TEXAS WATER DEVELOPMENT BOARD

Report on Appeal of the Reasonableness of the Desired Future Condition

Adopted by the Groundwater Conservation Districts in Groundwater

Management Area 9 for the Edwards-Trinity (Plateau) Aquifer

Figure 8. Simulated pumping versus drawdown in the Edwards Group of the Edwards-Trinity (Plateau) Aquifer in Kerr County under alternative initial conditions

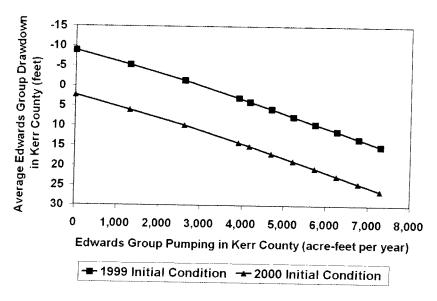
Based on the results summarized in Figure 8, it can be seen that when pumping is about 1,300 acre-feet per year under 1999 Initial Conditions (generally low groundwater levels), the groundwater levels will rise about 5.5 feet in the Kerr County portion of the Edwards Group of the Edwards-Trinity (Plateau) Aquifer. In contrast, when pumping is 1,300 acre-feet per year under 2000 Initial Conditions (generally high groundwater levels), the groundwater levels will decline about 5.5 feet in the Kerr County portion of the Edwards Group of the Edwards-Trinity (Plateau) Aquifer. Thus, it can be inferred that under "average" initial conditions, 1,300 acre-feet per year of pumping in the Kerr County portion of the Edwards Group of the Edwards-Trinity (Plateau) Aquifer would result in zero drawdown after 50 years. This estimate compares favorably with the managed available groundwater value of 1,263 acre-feet per year that was developed by TWDB staff using the groundwater availability model developed by Mace and others (2000), and extrapolating the results to areas of Kerr County that are outside the model domain. Thus, it can be concluded that the two models yield approximately the same result when simulating pumping to achieve zero drawdown over a 50-year period.

When pumping is set to the values presented in Table 3 (the groundwater availability estimates developed by Region J), drawdown ranges from about 8 to about 19 feet. Because the Plateau Water Planning Group (Region J) assigned its groundwater availability numbers according to "a maximum level of aquifer withdrawal that results in an acceptable level of long-term aquifer impact", then it follows that the Plateau Water Planning Group (Region J) considered this amount of drawdown to be "acceptable".

Figure 9. Simulated pumping versus springflow from the Edwards Group of the Edwards-Trinity (Plateau) Aquifer in Kerr County

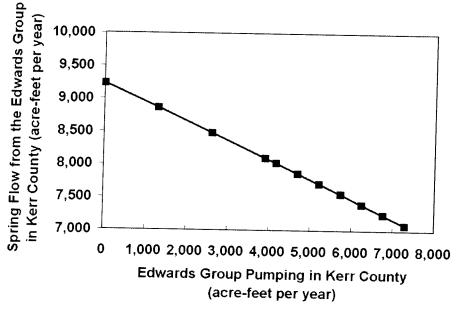
Pumping impacts to springflow in Kerr County are presented in Figure 9. Only one curve is presented as both initial condition scenarios yielded results that were less than one acre-foot per year different. When pumping is zero, springflow (9,232 acre-feet per year) is nearly identical to the average springflow from the calibration period (9,255 acre-feet per year), previously presented in Figure 6. As pumping increases, springflow decreases due to the pumping. This is consistent with the conceptualization that any increase in pumping will result in some degree of impact.

When pumping is set to the values previously presented in Table 3 (the groundwater availability estimates developed by Region J), springflow is about 7,700 acre-feet per year, a 16 percent decline. Because the Plateau Water Planning Group (Region J) assigned its groundwater availability numbers according to "a maximum level of aquifer withdrawal that results in an acceptable level of long-term aquifer impact", then it follows that the Plateau Water Planning Group (Region J) considered this reduction of springflow to be "acceptable".

Under the 1999 Initial Condition scenario, zero drawdown can be achieved with pumping up to about 3,000 acre-feet per year. However, as previously noted, this is based on a temporarily low groundwater level condition as the starting point. It can be seen that under that condition, zero drawdown can be achieved, but spring flow would be about 8,400 acre-feet per year, or an impact of about 9 percent from the springflow associated with zero pumping. If pumping were limited to 1,300 acre-feet per year (zero drawdown under average initial conditions and approximately equal to the managed available groundwater value), springflow would be reduced about 4 percent from the springflow associated with zero pumping.

Figure 14. Historic pumping in the Edwards Group of the Edwards-Trinity (Plateau) Aquifer in Kerr County, and two alternative estimates of future pumping

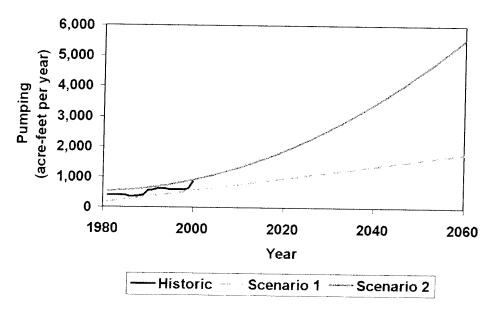
Headwaters Groundwater Conservation District does not issue permits for wells in the Edwards Group of the Edwards-Trinity (Plateau) Aquifer, and, thus, groundwater pumping is limited to exempt domestic and livestock wells. Therefore, it is reasonable to assume that any increases in pumping will be the result of increases in exempt wells (primarily domestic wells). Figure 13 presents historic pumping from the Edwards Group of the Edwards-Trinity (Plateau) Aquifer in Kerr County based on data from Anaya and Jones (2009), and previously presented in Table 2 along with two curves that estimate the future increase in pumping through 2060 by extrapolating the 1981 to 2000 trend. Scenario 1 represents the pumping increase by connecting the relative maxima in the historic 1981 to 2000 data; Scenario 2 represents the pumping increase by connecting the relative minima in the historic 1981 to 2000 data. Estimated 2000 pumping was about 870 acre-feet per year. Estimated pumping in 2060 ranges from about 1,800 acre-feet per year to about 5,600 acre-feet per year.

The managed available groundwater value issued by the Texas Water Development Board for Kerr County in the Edwards Group of the Edwards-Trinity (Plateau) Aquifer is 1,263 acre-feet per year. Based on Scenario 1, this managed available groundwater value

The establishment of a desired future condition for the Edwards Group of the Edwards Trinity (Plateau) Aquifer is dependent on the estimated future pumping from exempt wells. Based on the analysis presented, a 2060 pumping rate of about 4,000 acre-feet per year from the Edwards Group of the Edwards-Trinity (Plateau) Aquifer in Kerr County appears to be an intermediate estimate of the two pumping increase scenarios previously presented in Figure 13. This would result in between 3 and 15 feet of drawdown (depending on the initial condition), about a 12 percent impact to springflow, and about 2,000 acre-feet per year of increased stream recharge. Under "average" initial conditions, drawdown associated with 4,000 acre-feet per year of pumping from the Edwards Group of the Edwards-Trinity (Plateau) Aquifer would result in about 9 feet of drawdown, about
